Report: TAB Report
Function: Test, Adjust, & Balance
Date: 01/26/2026
Completed By: National TAB

PROJECT
08-18-25 WAWA #6620 ELKTON, VA

Project Issue Information

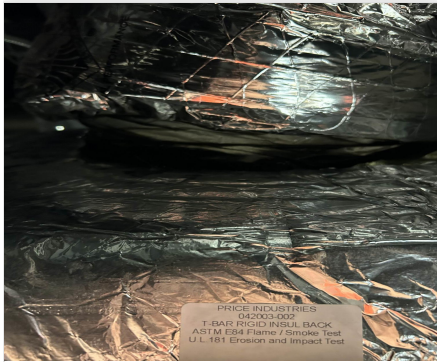
Issue Name : Diffuser EF1-2 - Wrong Grille Type
Description : Exhaust diffuser EF1-2 (women's restroom) is using a SD-5 supply grille instead of the required EG-1 exhaust grille. The supply and exhaust grilles in the restroom appear to be swapped. Recommend installing correct grille.
Created By : National TAB **Assigned To :** National TAB - Dan Hertenstein
Status : Open
Priority : Low **Asset Tag :**
Originated Date : 08/20/2025 - Mark Johnson - National TAB

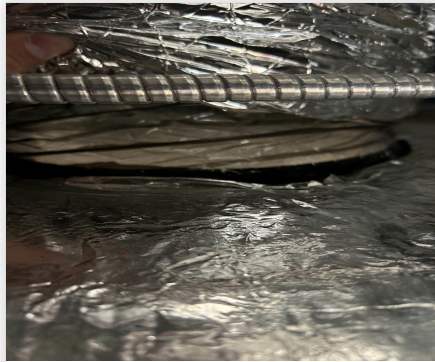
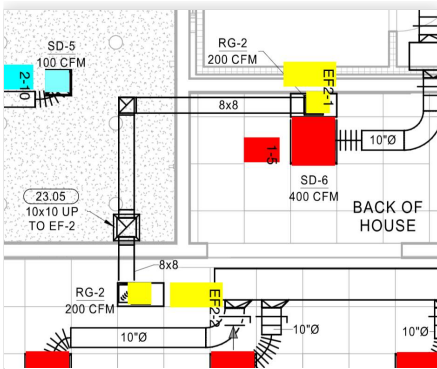
Issue Name : Diffusers 1-7, 1-8 - Duct Connection
Description : Flex duct for supply diffusers 1-6, 1-7 and 1-8 (food service) are fit loosely over the diffuser necks. Recommend securing with zip ties.
Created By : National TAB **Assigned To :** National TAB - Dan Hertenstein
Status : Open
Priority : Medium **Asset Tag :**
Originated Date : 08/21/2025 - Mark Johnson - National TAB

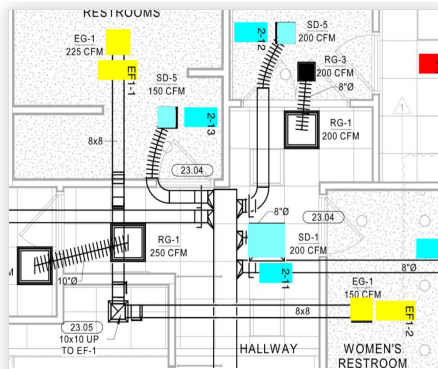
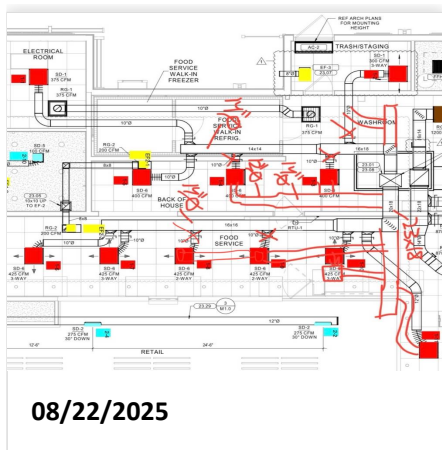
Issue Name : Exhaust Ductwork
Description : Exhaust fan ductwork is constructed differently from plans. Mechanical plans specify 8X8 square duct for both rooftop exhaust fans. Installed is 8" round duct with flex at the diffuser connections.
Created By : National TAB **Assigned To :** National TAB - Dan Hertenstein
Status : Open
Priority : InfoOnly **Asset Tag :**
Originated Date : 08/20/2025 - Mark Johnson - National TAB

- **08/22/2025 National TAB - Mark Johnson**
 - Exhaust fans are fully balanced and are running below FLA and design static pressure.

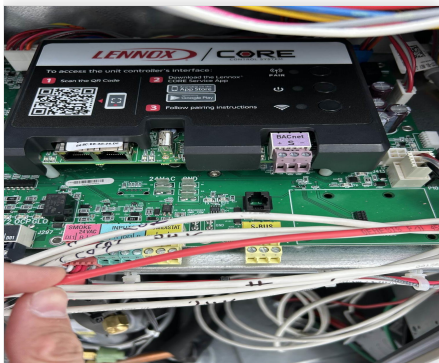
Issue Name : RTU 1 Ductwork
Description : RTU 1 ductwork is constructed differently from plans. See approximate as-built sketch attached. The unit outputs design airflow while running below FLA.
Created By : National TAB **Assigned To :** National TAB - Dan Hertenstein
Status : Open
Priority : InfoOnly **Asset Tag :**
Originated Date : 08/22/2025 - Mark Johnson - National TAB

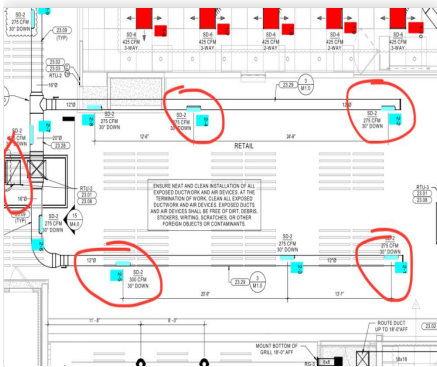
Issue Name : RTU 2 - Core Controls
Description : RTU 2's Core control board is not functional. The unit will power on, but the fan remains idle, and parameters cannot be adjusted. Unit cannot be balanced until resolved.
Created By : National TAB **Assigned To :** National TAB - Dan Hertenstein
Status : Open
Priority : Urgent **Asset Tag :**
Originated Date : 08/20/2025 - Mark Johnson - National TAB

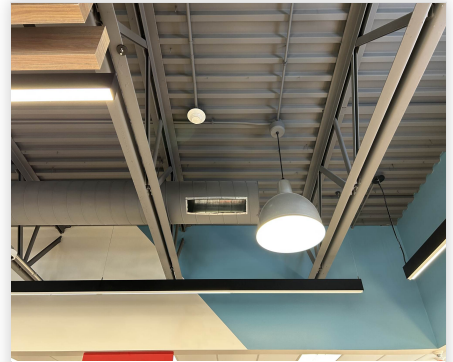
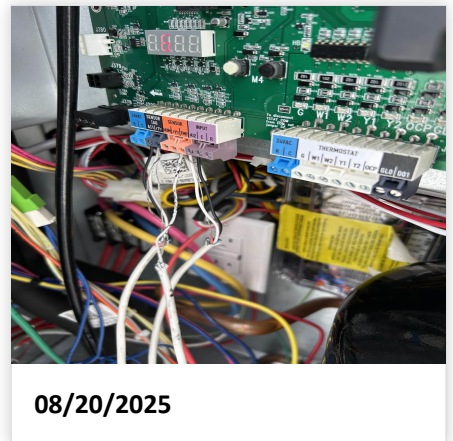
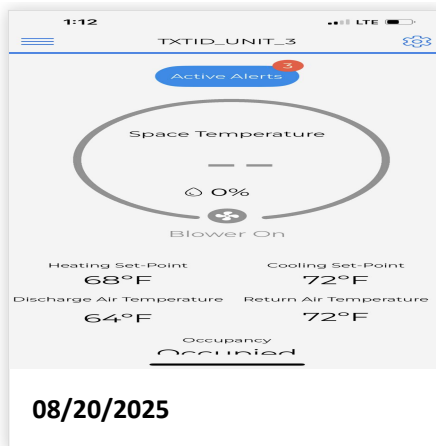
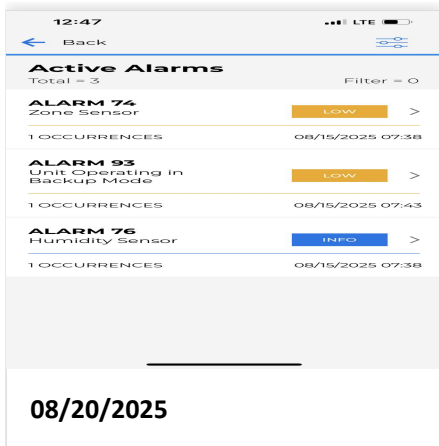
Issue Name : RTU 2 - Missing Supply/Return Grilles
Description : RTU 2 is missing several sidewall grilles along the supply duct, and the return grille. Must be installed to balance the individual diffusers.
Created By : National TAB **Assigned To :** National TAB - Dan Hertenstein
Status : Open
Priority : High **Asset Tag :**
Originated Date : 08/20/2025 - Mark Johnson - National TAB

- **08/20/2025 National TAB - Mark Johnson**
 - Per GC, missing grilles are on order.

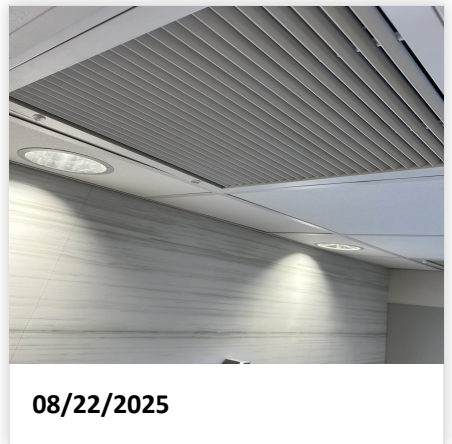
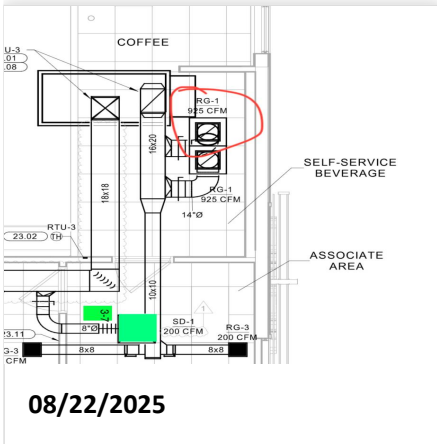
Issue Name : RTU 3 Return Grille Open
Description : A return grille for RTU 3 is stuck partially open. It appears that the hinge is damaged on one side. Recommend repair.
Created By : National TAB **Assigned To :** National TAB - Dan Hertenstein
Status : Open
Priority : Low **Asset Tag :**
Originated Date : 08/22/2025 - Mark Johnson - National TAB
